UNITED STATES PATENT AND TRADEMARK OFFICE

APPLICATION NO.	FILING DATE	FIRST NAMED INVENTOR	ATTORNEY DOCKET NO.	CONFIRMATION NO.
10/628,013	07/25/2003	Daniel Dietzel	3401-138	3993

Office Action Summary	Application No.	Applicant(s)	
	10/628,013	DIETZEL ET AL.	
	Examiner	Art Unit	
	Michael J. Araj	3733

DETAILED ACTION

Figure 1

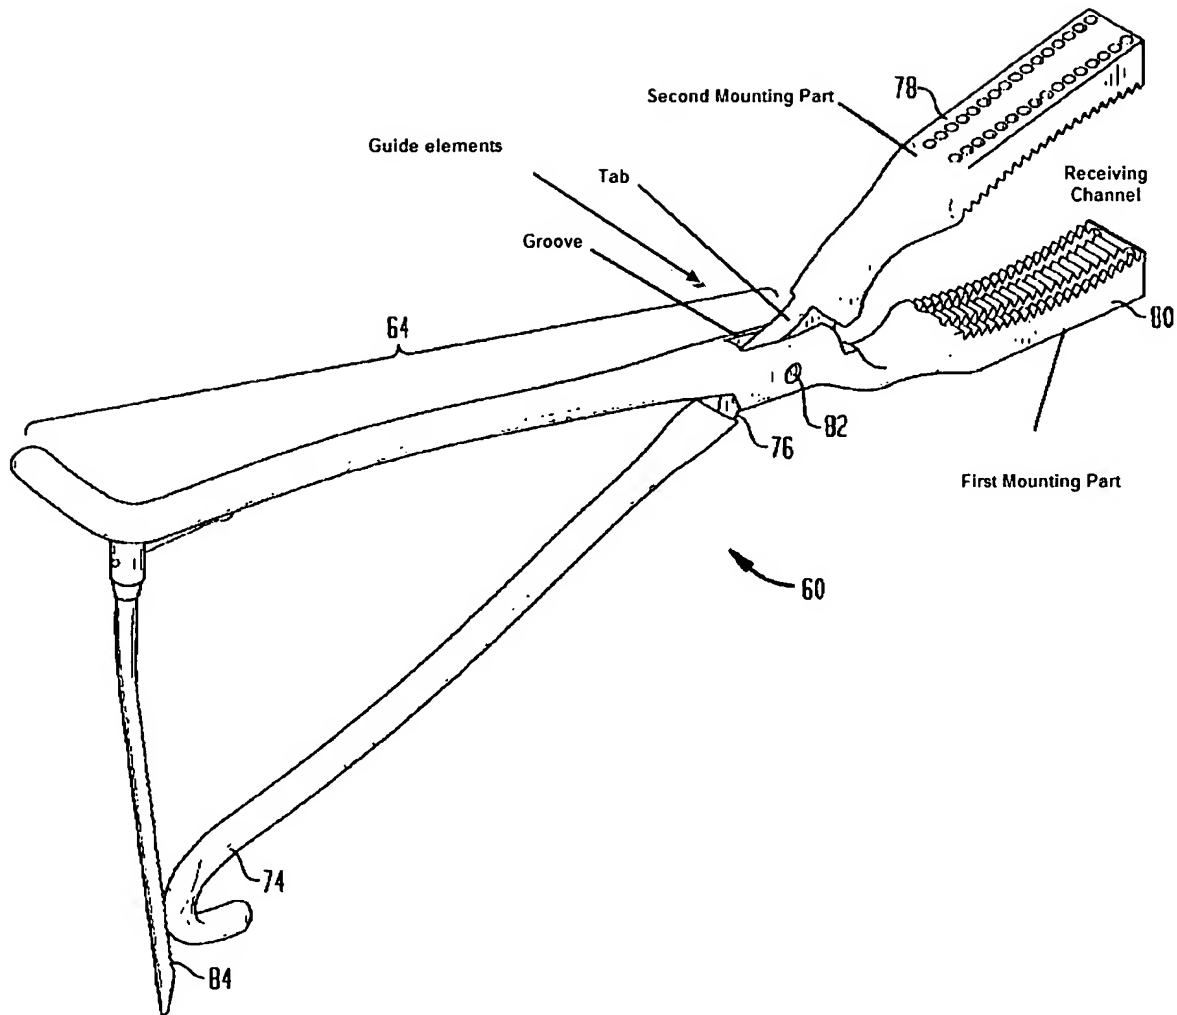
Claims 12-15, 19 and 25 are rejected, as understood, under 35 U.S.C. 102(e) as being anticipated by Abdelgany et al. (U.S. Publication No. 2002/0082604).

Abdelgany et al. disclose a device that includes a first mounting part defining a receiving channel that has a longitudinal axis and the mounting part further defines at least one slot (See Fig. 7C) therethrough at an angle oblique to the longitudinal axis of the receiving channel. The first mounting part defines two intersecting slots in the region of the receiving channel each having an acute but different angles relative to the

longitudinal axis of the receiving channel, where the second mounting part receivable on the first mounting part has at least one slot arranged. The second mounting part also defines a receiving channel where the first and second mounting parts face each other when second mounting part is received on first mounting part (see Figure 1 below). Abdelgany et al. also discloses that each first and second mounting parts include guide elements positioning the parts relative to each other such that the slots and receiving channels face each other and are arranged congruently. With regard the statement of intended use and other functional statements, they do not impose any structural limitations on the claims distinguishable over Abdelgany et al., which is capable of being used as claimed if one so desires to do so. *In re Casey*, 152 USPQ 235 (CCPA 1967) and *In re Otto*, 136 USPQ 458, 459 (CCPA 1963). Furthermore, the law of anticipation does not require that the reference "teach" what the subject patent teaches, but rather it is only necessary that the claims under attack "read on" something in the reference. *Kalman v. Kimberly Clark Corp.*, 218 USPQ 781 (CCPA 1983). Furthermore, the manner in which a device is intended to be employed does not differentiate the claimed apparatus from prior art apparatus satisfying the claimed structural limitations. *Ex parte Masham*, 2 USPQ2d 1647 (1987).

Figure 2

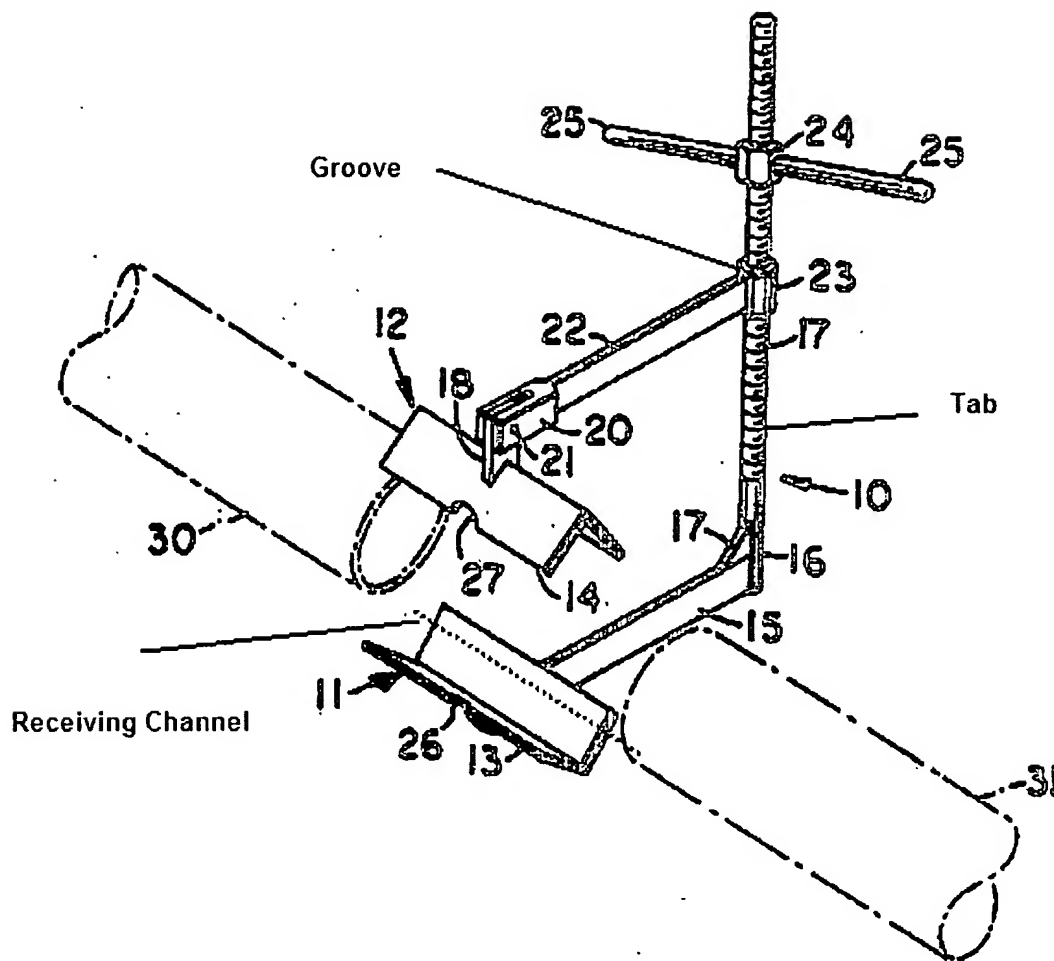
Claims 12, 17 and 21 is rejected under 35 U.S.C. 102(b) as being anticipated by Hilburn (U.S. Patent No. 3,596,898).

Hilburn discloses a device that includes a first mounting part (12) defining a receiving channel that has a longitudinal axis and the mounting part further defines at least one slot (27) therethrough at an angle oblique to the longitudinal axis of the receiving channel (see Figure 2 below) having a V-shaped cross section. A second

mounting part (11)receivable on the first mounting part has at least one slot (26) arranged so as to be congruent to the slot of the first mounting part. The second mounting part also defines a receiving channel where the first and second mounting parts face each other when second mounting part is received on first mounting part. Hilburn also discloses that each first and second mounting pars include guide elements positioning the parts relative to each other such that the slots and receiving channels face each other and are arranged congruently. Said guide elements of said first mounting part comprise of grooves and said guide elements of said second mounting art comprise tabs receivable in said grooves. The tabs and grooves extend in a longitudinal axis that is normal to the longitudinal axis of the receiving channel and normal to the surface on with the receiving channel is defined (see Figure 2 below).
